## TENANT IMPROVEMENT PLAN CHECK COMMENTS

<b>PLAN CHECK NO:</b>	10173635,6,7		
<b>PROJECT ADDRESS:</b>	1831 S Ritchey St, 1917 E St. Andrews AND 1918 E Glenwood Pl.		
<b>PLAN CHECK ENGINEER:</b>	Kwak, Jason	<b>TEL: 714</b>	647-5866
		<b>FAX: 714</b>	647-5897
<b>TYPE OF CONSTRUCTION:</b>	V B		
<b>OCCUPANCY CLASSIFICATION(S):</b>	B, S-1		
<b>PLAN CHECK DATES:</b>		<b>REMARKS/RECHECK ITEMS:</b>	
<b>APPLICATION</b>	11/7/2011	_____	
<b>INITIAL REVIEW</b>	11/23/2011	_____	
<b>EXPIRATION</b>	5/5/2012	_____	
<b>RECHECKS:</b>	1. _____	<b>PROJECT APPLICANT CONTACT PERSON:</b>	
	2. _____	Michael Santillan	
	3. _____	<b>TEL:</b>	(949)716-9990
<b>VALUATION:</b>	\$30,000.00	<b>FAX:</b>	_____
<b>FLOOD ZONE:</b>	X-0602320277J	<b>EMAIL:</b>	michael.santillan@nationaleng.com

RE: 1831 S. Ritchey Street  
Plan Check # 10173635

**Voluntary Seismic Strengthening**  
 AN INDUSTRIAL BLDG. RETROFIT  
 1831 S. RITCHEY ST. BLDG. B  
 SANTA ANA CA. 92705-5138

**ADA UPGRADES PLAN**

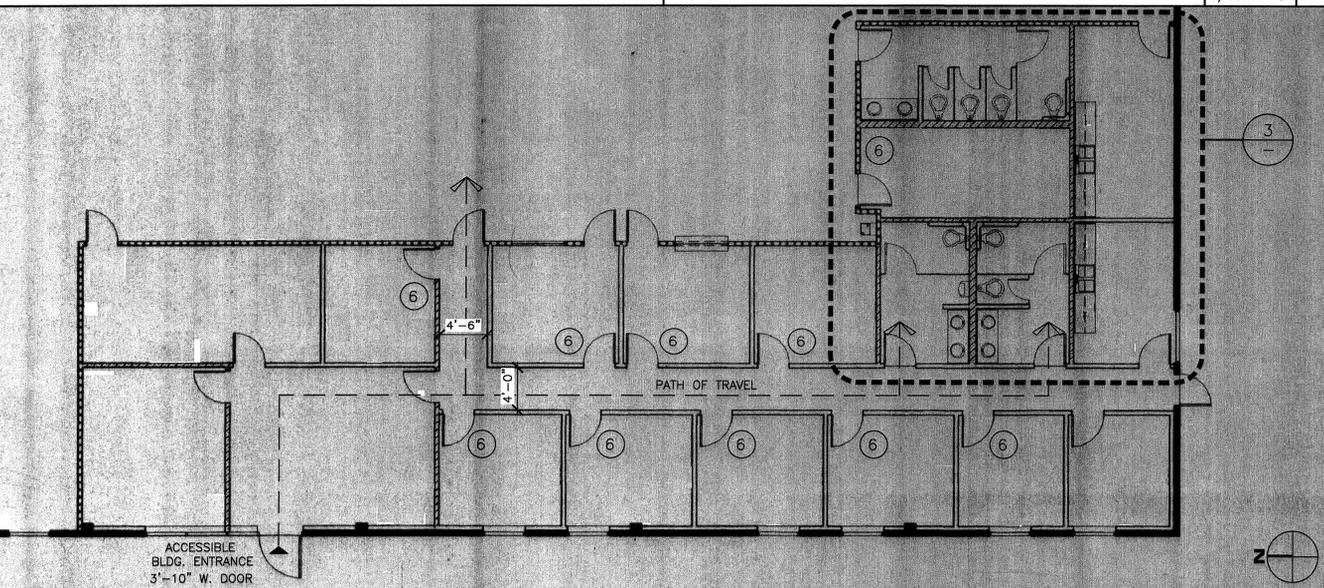
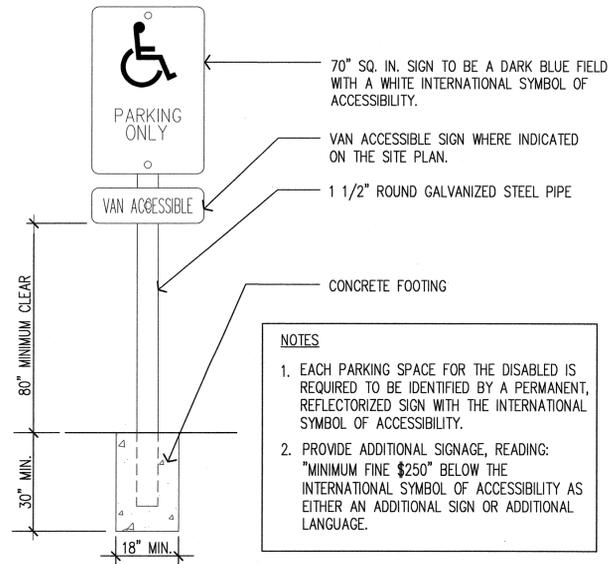
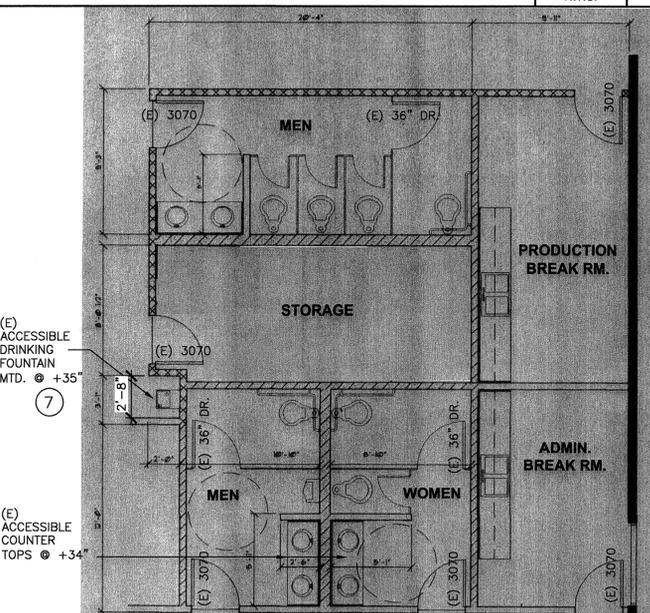
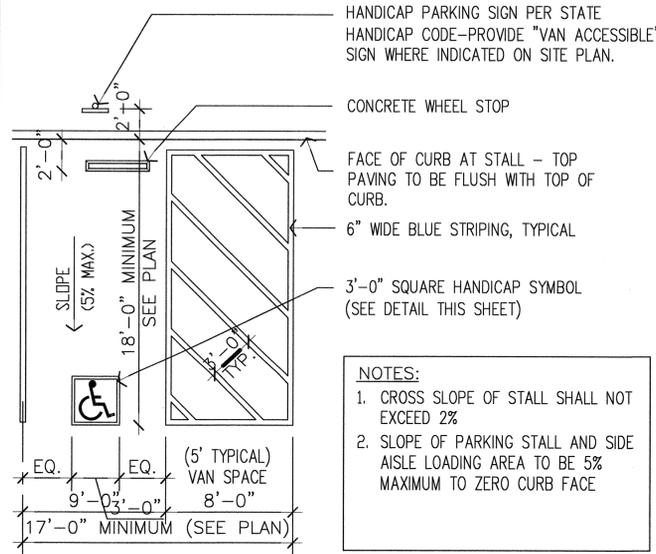
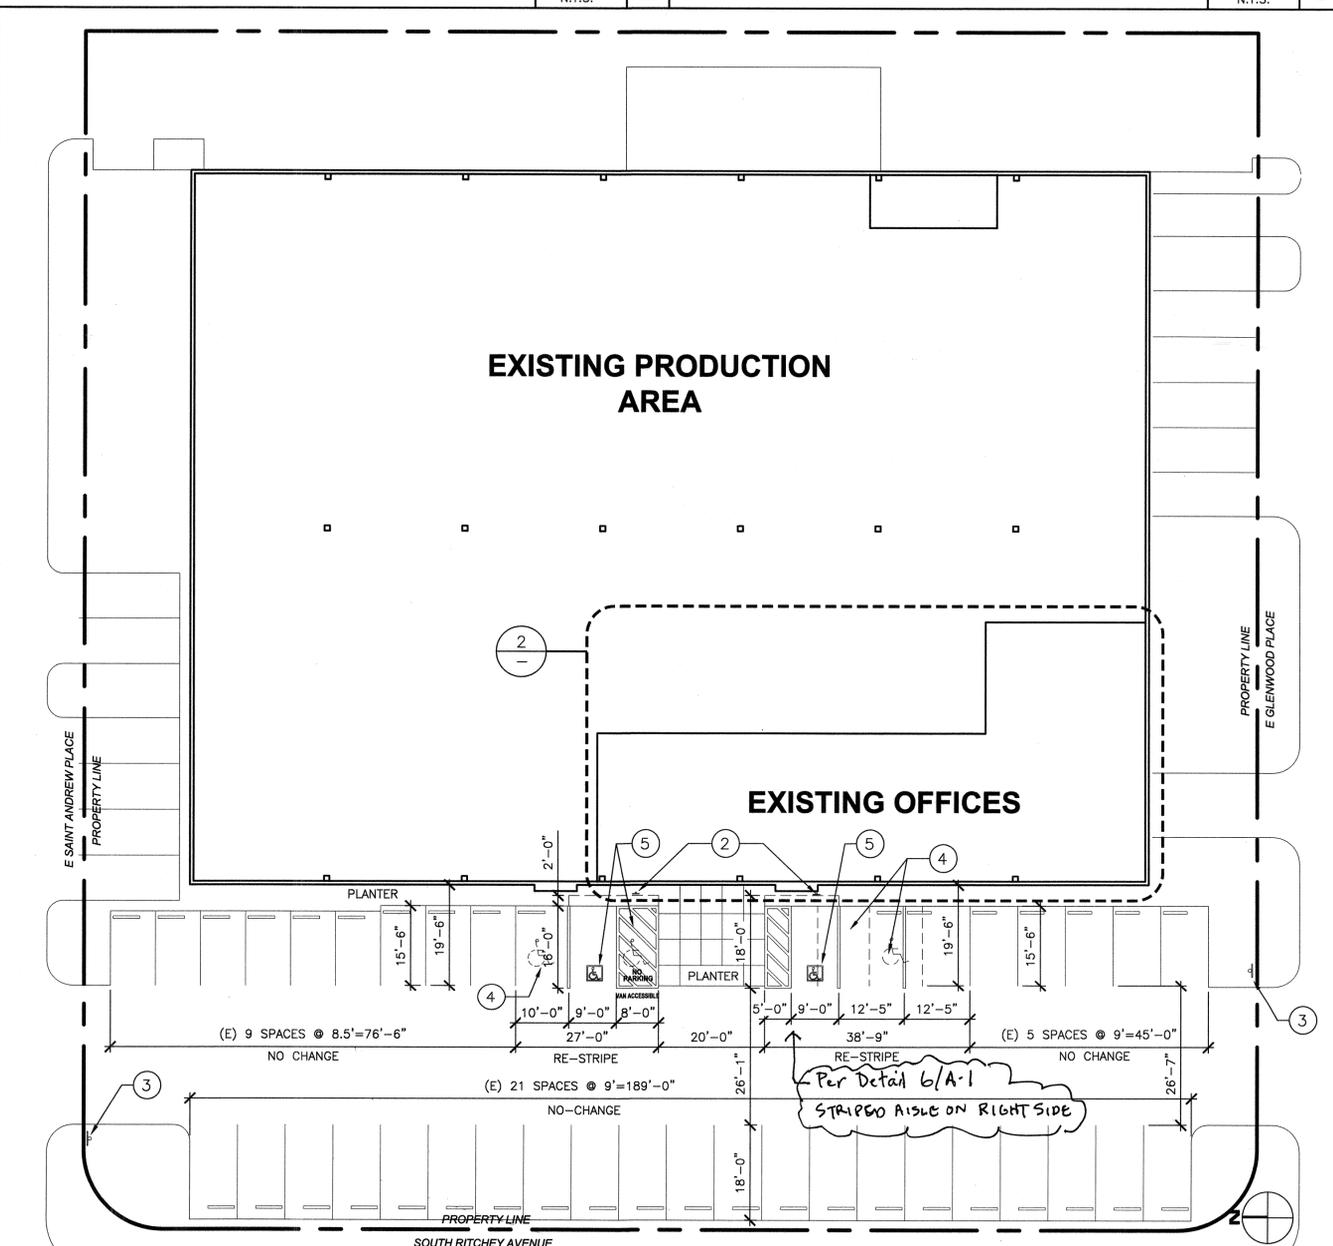
5. The drawings/information submitted for Building Safety Division review is incomplete. The applicant shall, prior to resubmitting, complete all construction documents to show compliance with the 2010 California Building Standards Code with local amendments. – Provide required disabled accessible upgrade proposal with plans.

8. **Show on the plans:**
  - Occupancy Classification(s)
  - Type of Construction
  - Fire Sprinkler System
9. It is the project designer's/property owner's responsibility to show compliance on the drawings with all applicable Federal and State Accessibility Standards.

- Parking, signage and alarms
11. Priority shall be given to those elements that will provide the greatest access in the above order.
12. Valuation of proposed project is calculated as \$\_\_\_\_\_. A minimum of 20% of valuation of construction is required to be spent towards providing disabled access in the priority order noted in the immediate previous item as noted in CBC Section 1134B. Revise the drawings to show compliance. Show both existing elements and how they will be upgraded to current standards.

**-Response: See sheet A-1, which shows proposed ADA upgrades**

**-Response: Proposed ADA upgrades are now shown on the new sheet A-1**

**-Response: see sheet A-1**

CONTINUITY TIE SCHEDULE					
MARK	MIN MEMBER THICKNESS	HARDWARE MANUFACTURER	HARDWARE	ANCHOR ROD SIZE	LARR #
DEFAULT	4x	ZONE 4	T2 24-4	1/2"	25334

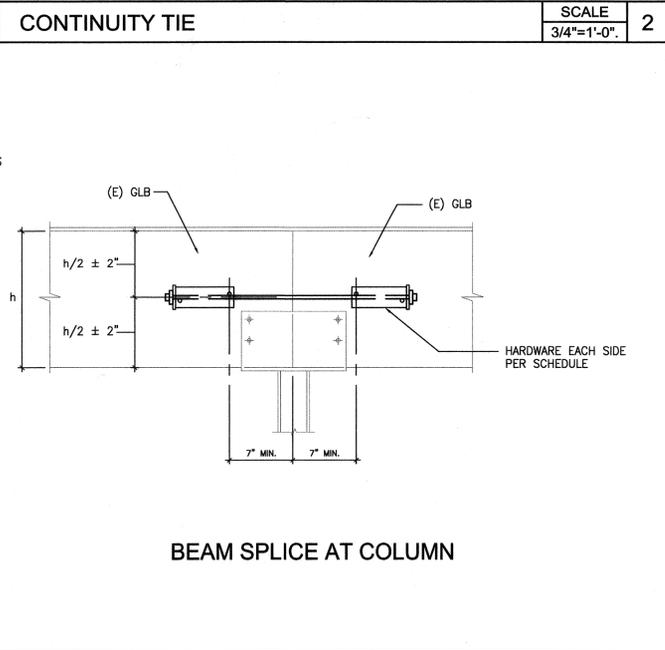
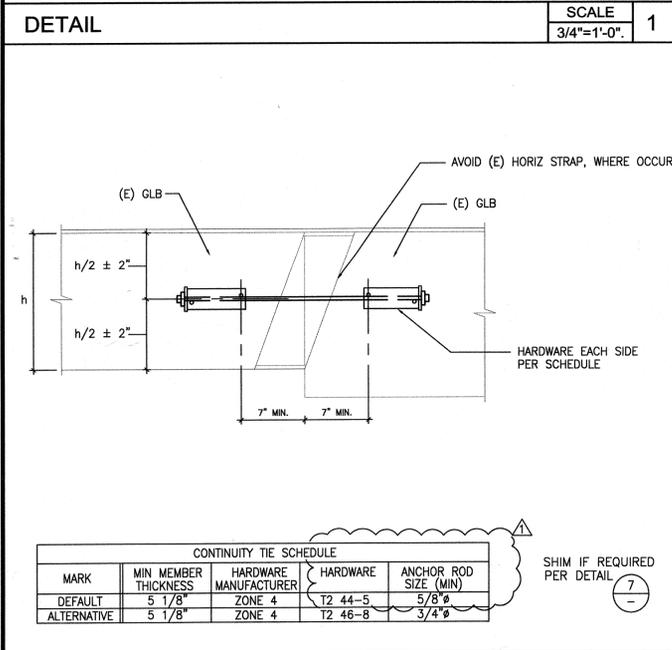
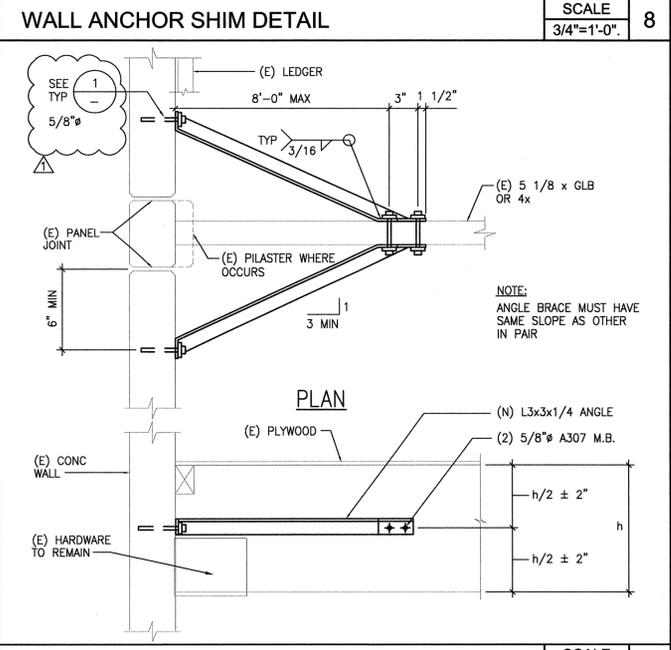
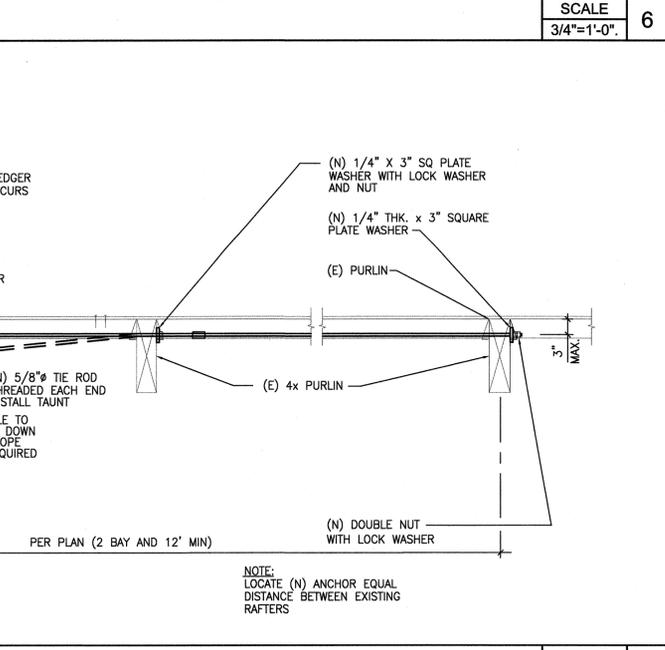
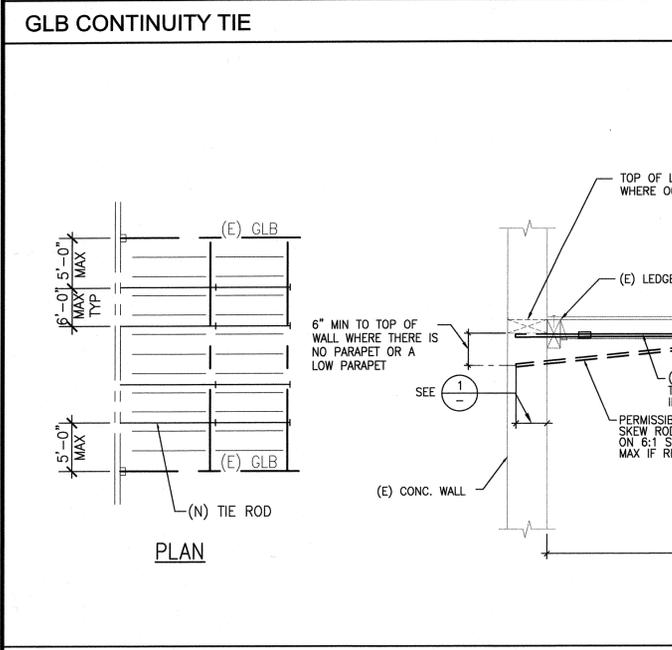
13. Provide completed disabled accessible compliance form (attached) with each project.
14. Provide ICC or LA RR listing number on plans for Zone 4 hardware.

*Provide ICC or LARR listing number on plans for Zone 4 hardware*

**Response: Complied. The LARR is 25334 and approved as of November 1, 2011. See structural plans detail 4/SD-1. As part of this approval, Zone4 revamped their product line and developed new capacities which I have attached.**

- The old continuity tie T2-44-6 is now a T2-44-5 with greater capacity (Details 2 & 6/SD1).
- The old wall anchor T2-24-6 is now a T2-24-4 with greater capacity (Detail 4/SD1).
